**Re: SSD 8894 Tower B (Detailed Design and Construction) at 12 Frederick Street,
St Leonards**

**SUBMISSION TO SSD 17 8894 APPLICATION NORTH SHORE PRIVATE HOSPITAL (TOWER B) STAGE 2
DESIGN AND CONSTRUCT, 12 FREDERICK STREET ST LEONARDS**

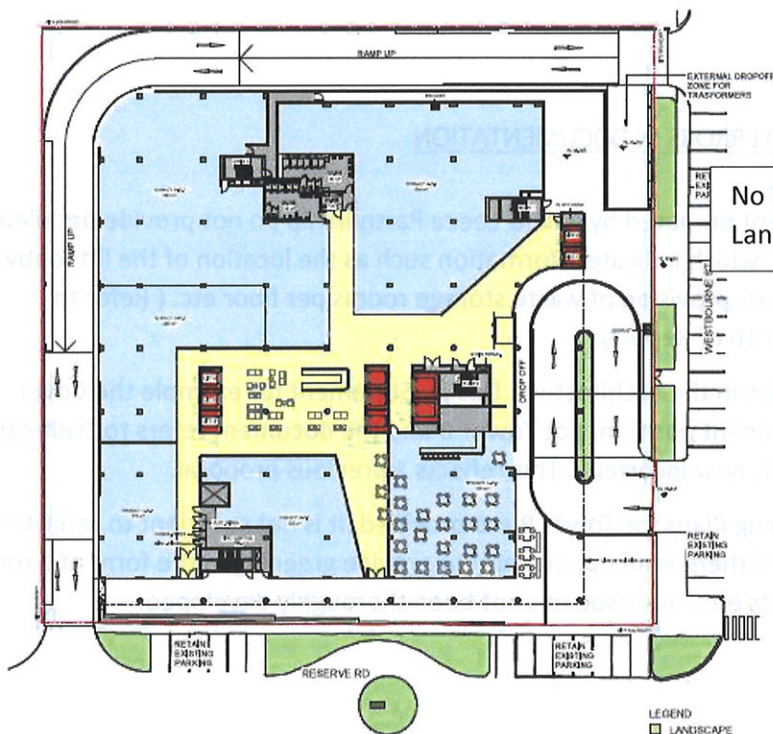
The Architectural Design Statement prepared by Billard Leece Partnership do not provide detailed DA level Architectural floor plans, which indicate information such as the location of the lift lobby, consulting room sizes and numbers, provision of waste storage rooms per floor etc. (Refer to extracts below, from page 13 and 16 of Report).

No detailed floor plans provided.

Insufficient documentation submitted to undertake assessment.

No reference to Tower B
Landscaping or greening at all.

- > Detailed DA level Architectural Floor Plans and Landscape Plans are to be provided to enable accurate assessment of the proposed development. These plans are to include details of all room uses, windows, doors, access arrangements etc and details of any proposed landscape treatments.
